Kirklees Local Plan

**Response to the Inspector's
Matters, Issues and Questions (MIQs)**

**Matter 2 – Spatial Development Strategy
with specific reference to
Land at Grimescar Road,
Birchcliffe – Site MX1904**

**Bradley Park Golf Course, Huddersfield
(Site References H351 and H1747)
Proposed Residential Allocation within Kirklees Site
Allocations Plan
Highway Documentation Review**

1. COMMENTS PROVIDED ON FORE CONSULTING DRAWING NUMBER: 3363 SK001 02

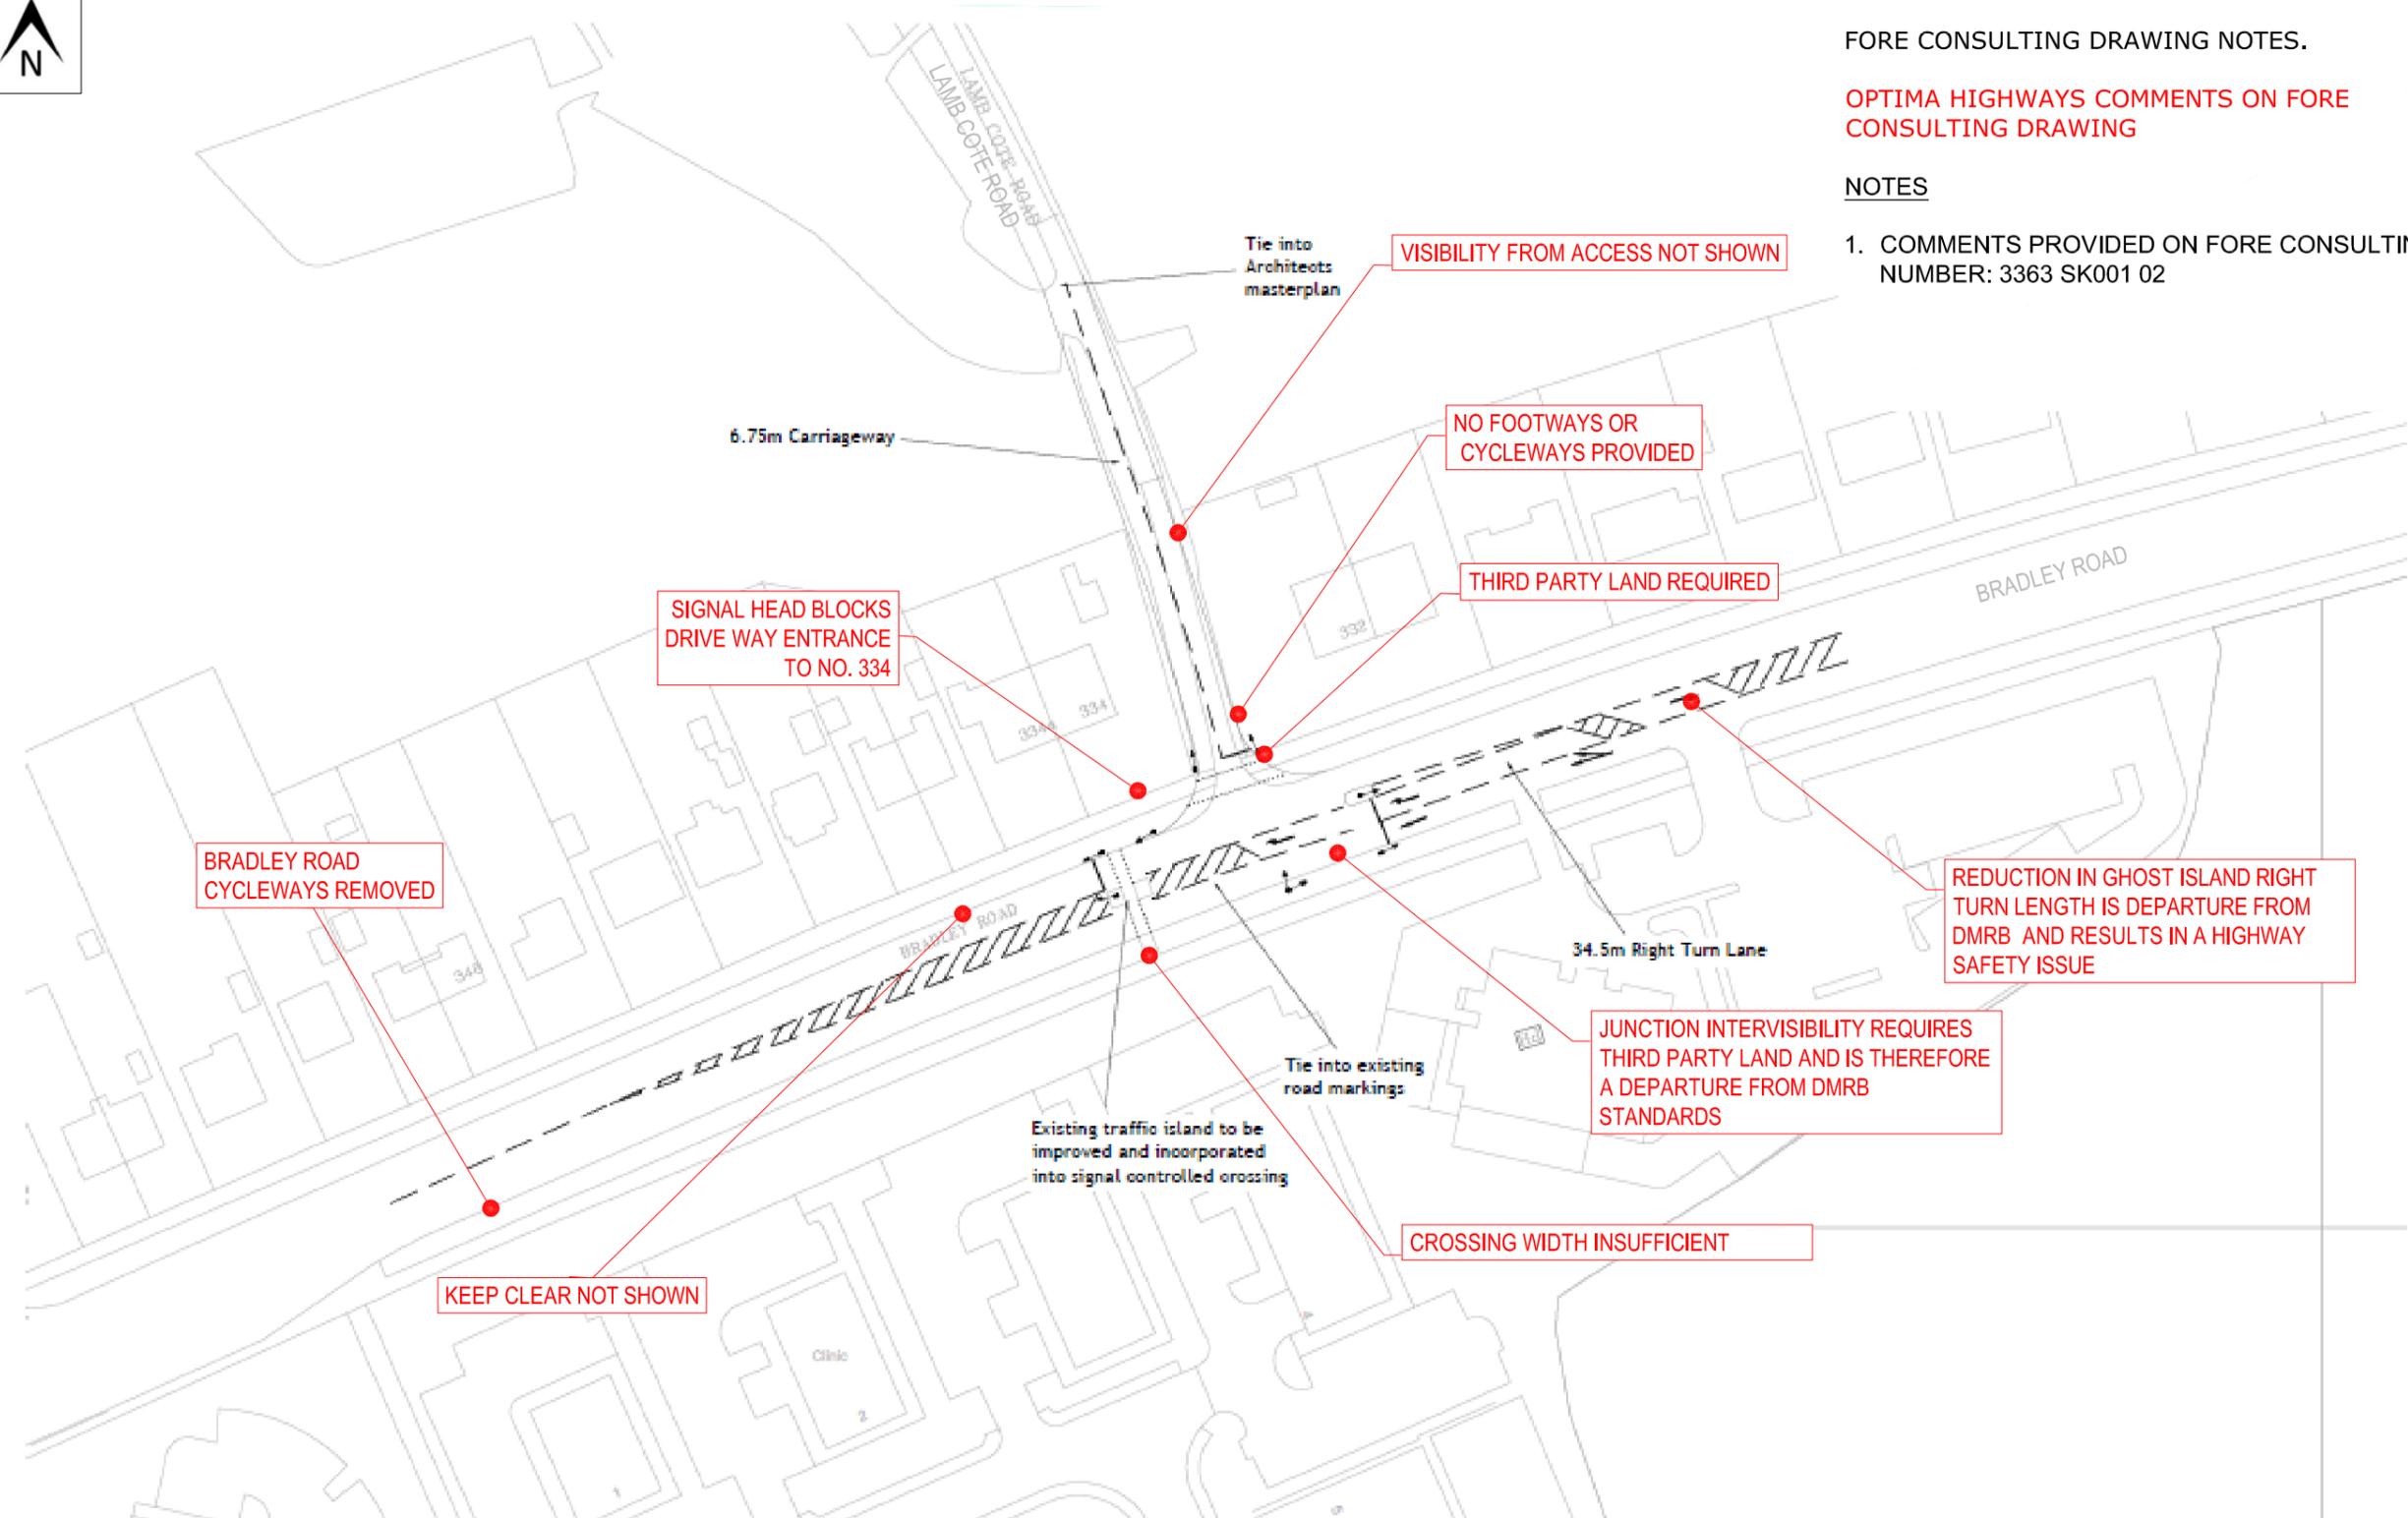
OPTIMA HIGHWAYS COMMENTS ON FORE CONSULTING DRAWING

PROJECT	BRADLEY PARK GOLF COURSE, HUDDERSFIELD
DRAWING TITLE	OPTIMA COMMENTS ON TITHE HOUSE WAY POTENTIAL ACCESS

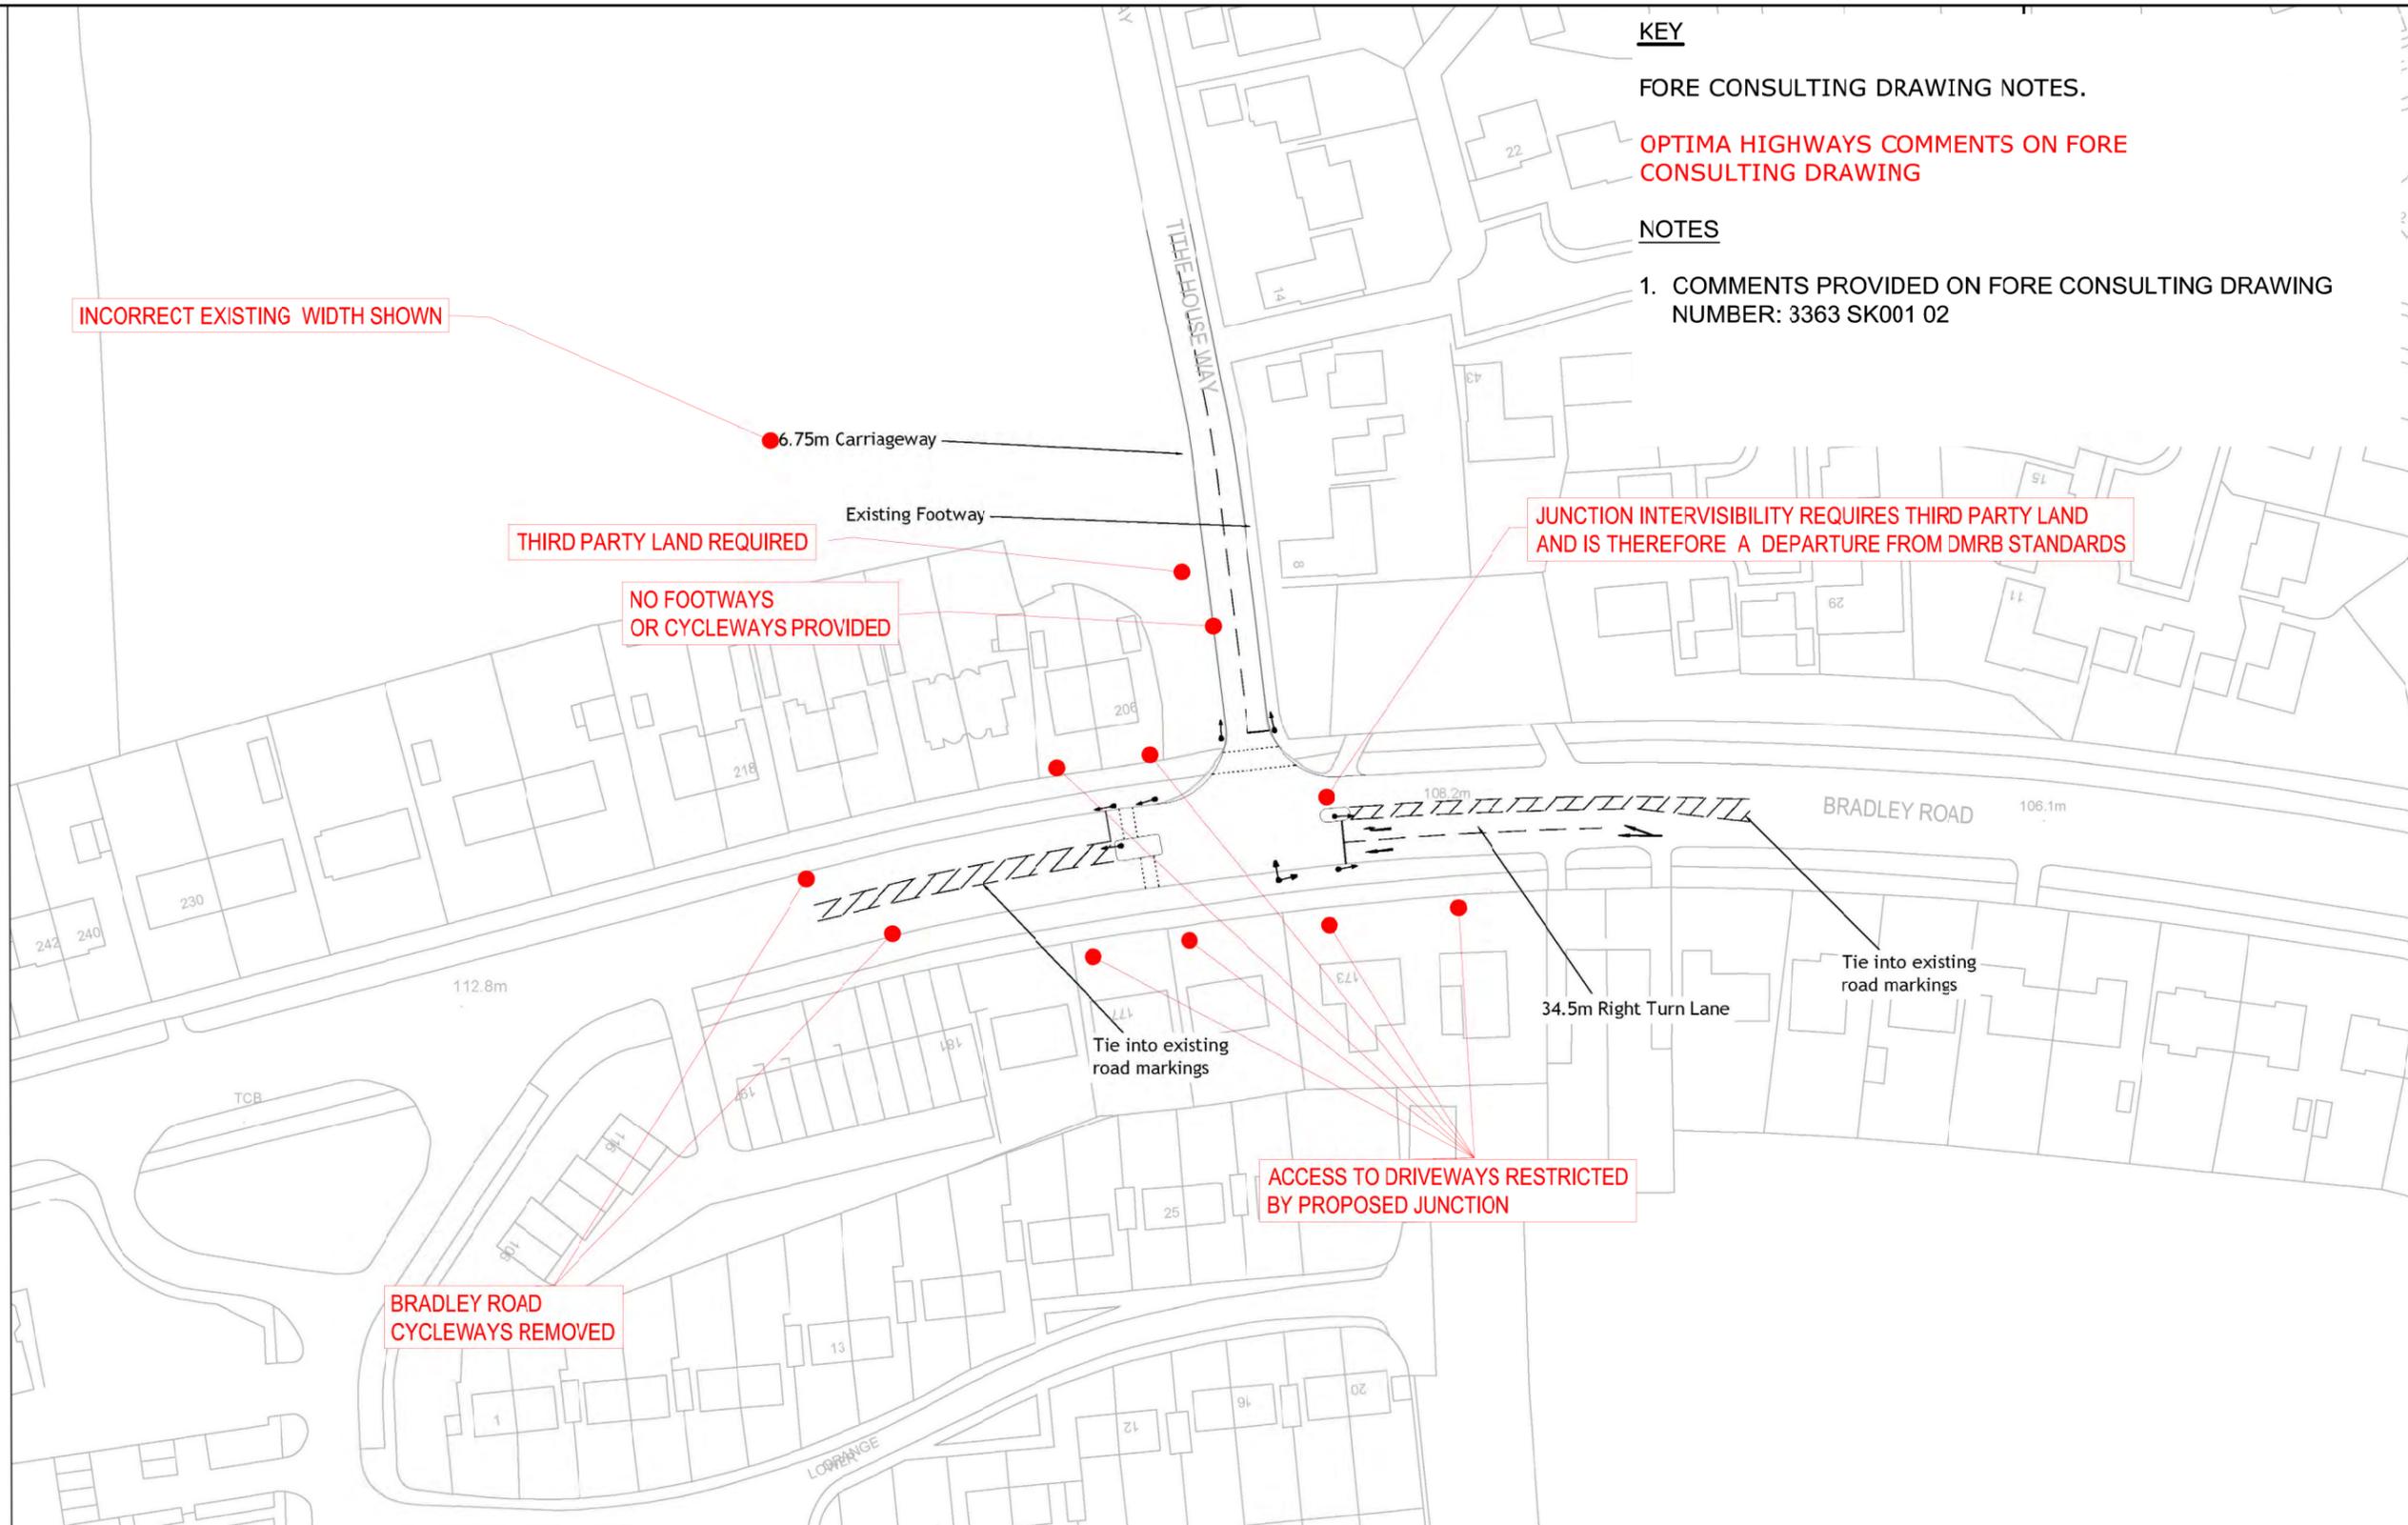
OPTIMA HIGHWAYS COMMENTS ON FORE CONSULTING DRAWING

TITLE BRADLEY PARK GOLF COURSE
 FORE CONSULTING DRAWING 3367 SK001 01
 TRACKING

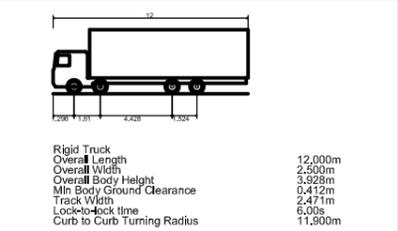
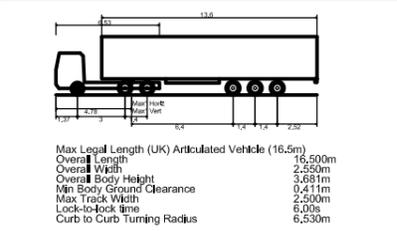
- A swept path analysis (attached in Appendix C) shows large vehicles would need to use both lanes to exit - which would reduce the capacity of the junction and could result in highway safety concerns;

TITLE	BRADLEY PARK GOLF COURSE FORE CONSULTING DRAWING 3367 SK001 02 TRACKING
REF	15117/ATR/02
SCALE	1:500 @ A3

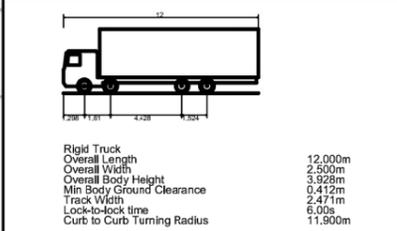
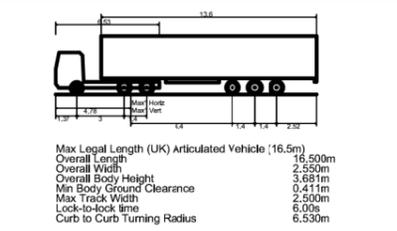
- A swept path analysis in Appendix C shows large vehicles aren't able to left turn into the Site or left turn out of the Site and therefore the servicing requirements of the Site (shops, refuse, sports facilities) cannot be undertaken from this access;
